Access Compliance Report

Public Rights-of-Way

(Curb Ramps)

Intersection ID: 47469	Main Street: KALISPELL_LN	Cross Street: ELENDIL_LN	Location: NW
ADA ID: AF18E100CE83	Ramp Type: Perp	Initial Pass/Fail: Pass	Overall Compliance: No
Severity Score: 5.25			
Codes/Mitigation Info/Possible Solution		Field Measurements/Component Compliance

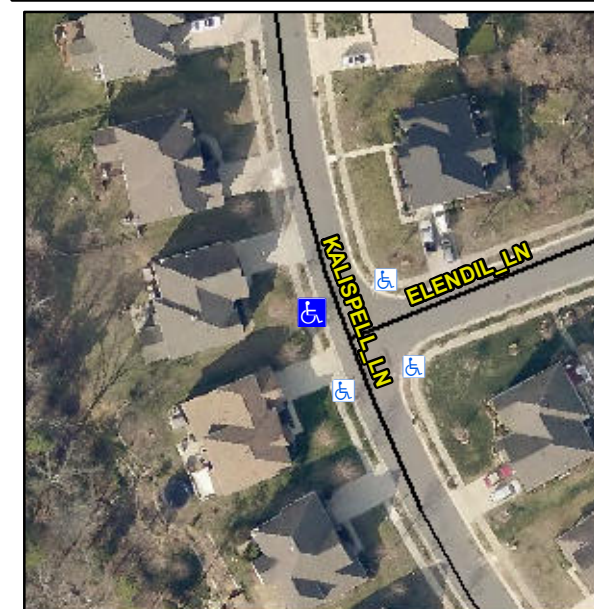
**Not Found, R305.2, R304.5.4,
R304.5.3**

Compliance	Description	Data	Compliance	Description	Data
N/A	Ramp Length (in)	47.0	Yes	Ramp Slope (%)	7.9
Yes	Ramp Width (in)	48.0	Yes	Ramp XSlope (%)	2.1
N/A	Flare Type LT	Sloped	N/A	Flare Type RT	N/A
N/A	Flare Slope LT (%)	7.0	Yes	Flare Slope RT (%)	3.0
N/A	Flare Traversable LT?	Yes	N/A	Flare Traversable RT?	Yes
Yes	Landing Length (in)	48.5	Yes	DWS Provided?	Yes
Yes	Landing Width (in)	48.0	Yes	DWS Contrast?	Yes
Yes	Landing Slope (%)	1.4	Yes	DWS Length (in)	24.0
Yes	Landing X Slope (%)	2.1	Yes	DWS Full Width?	Yes
N/A	Landing Curb? (Y/N)	No	No	DWS Offset (in)	7.0
N/A	Shared Landing?	No			
Yes	Gutter Ponding?	No	No	Gutter Slope (%)	9.4
Yes	Gutter Lip Ht (in)	0.0	No	Gutter X Slope (%)	2.7
N/A	Painted X Walk1?	No	N/A	Painted X Walk2?	N/A
	X Walk 1 Direction	To E		X Walk 2 Direction	N/A
N/A	X Walk 1 Width (in)	N/A	N/A	X Walk 2 Width (in)	N/A
	X Walk 1 Slope (%)	3.1		X Walk 2 Slope (%)	N/A
	X Walk 1 X Slope (%)	2.6		X Walk 2 X Slope (%)	N/A

**Remove & Replace Entire Ramp.
Remove & Replace Gutter.**
